## PRODUCT CHANGE NOTICE

### PCN Form (D4-E000-73)

**PCN#23-002****NOTIFICATION DATE: January 6, 2023****MODELS AFFECTED:**

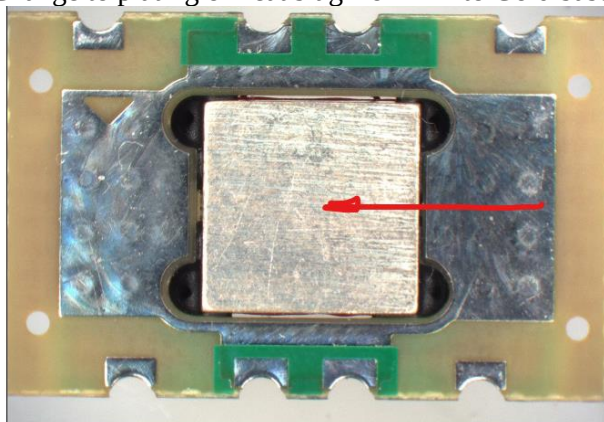
Change to plating of heat slug from Tin to Gold based plating (see red arrow for bottom side location of change)

**EFFECT OF CHANGE:**No change to FIT (Dimension) or FUNCTION (Performance)  
Change to FORM (Appearance),**REASON FOR CHANGE:**
